# Building Inspection Report

FANGS BUILDING INSPECTIONS

**Lotxx Fogarty Street Williams Landing , VIC**

Inspection Date:        18 Mar 2019

### **Cracking in Plaster Observed Width > 1mm**

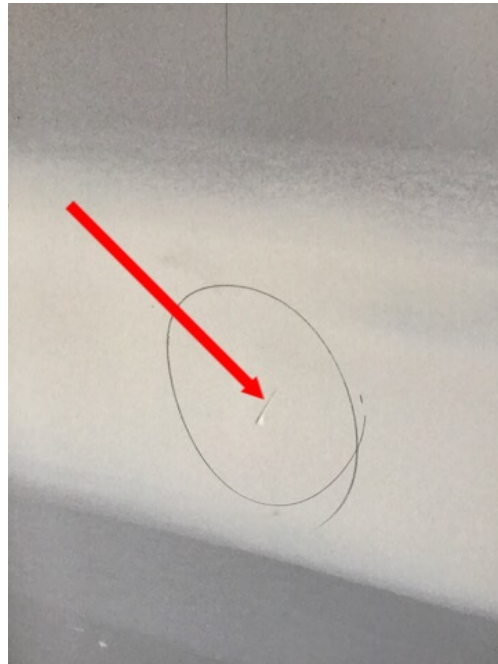
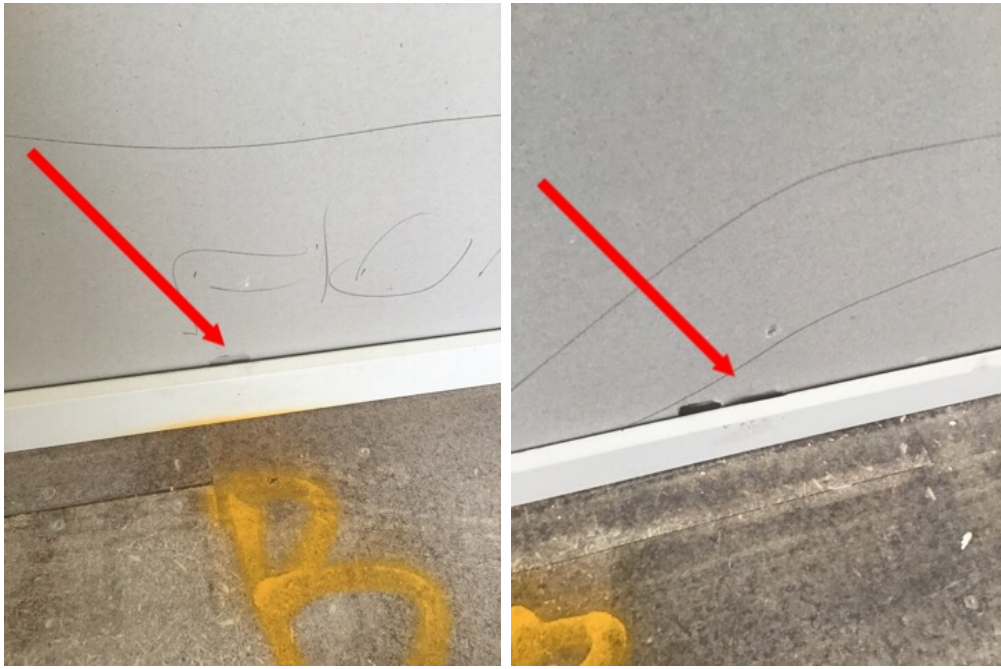
Minor crackings observed from the referred area exceed 1mm over the tolerance. Default finish level as level 4. Cracking in walls, ceilings and bulkheads is defective if it exists at handover or exceeds 1 mm in width within the first 24 months of completion and can be seen from a normal viewing position As per Standards and tolerance 2015 9.14

Cracking in recessed and butt joints is defective if it exists at handover or exceeds

1 mm in width within the first 24 months of completion and can be seen from a normal viewing position.

Incomplete noted

**Cracking in Plaster Observed**

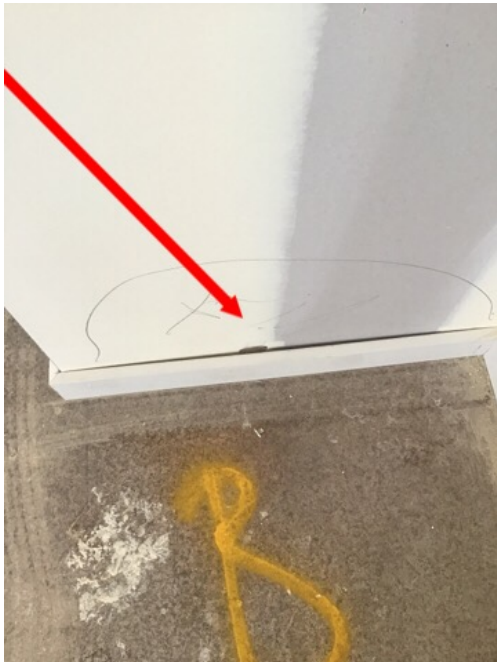
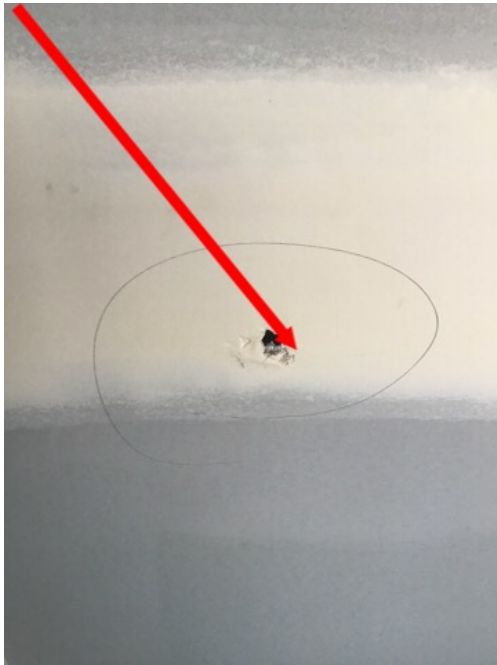
Dent on plaster wall noted

### **Straightness and Alignment of Plaster Cornices > 4mm for a 2m Distance**

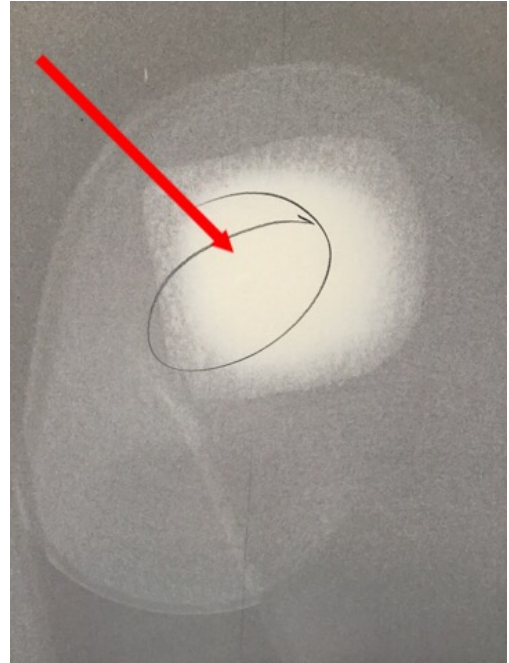
Straightness and alignment of plaster cornices are no more than 4mm within 2m as per Standards and tolerance 2015 9.17

## Perimeter Flashing Installation NOT Correct - Minimum 25mm Vertically Above Floor or 50mm Across Doorway

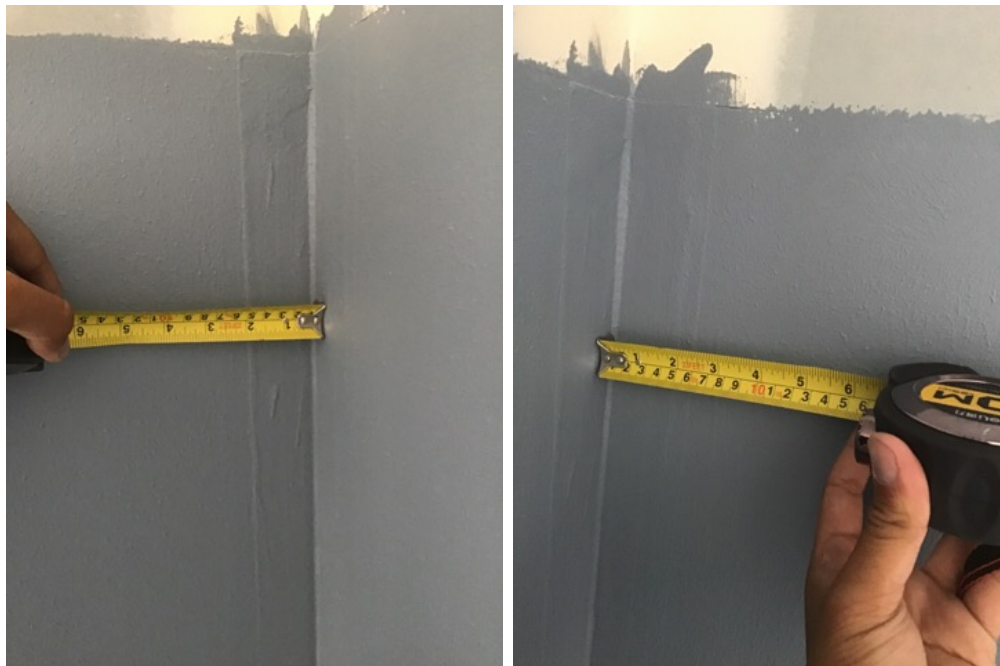
Perimeter flashing to wall/floor surfaces continuously sealed to the horizontal surface and have a vertical leg of a minimum of 25 mm above the finished floor level and the horizontal leg meet minimum width of 50 mm
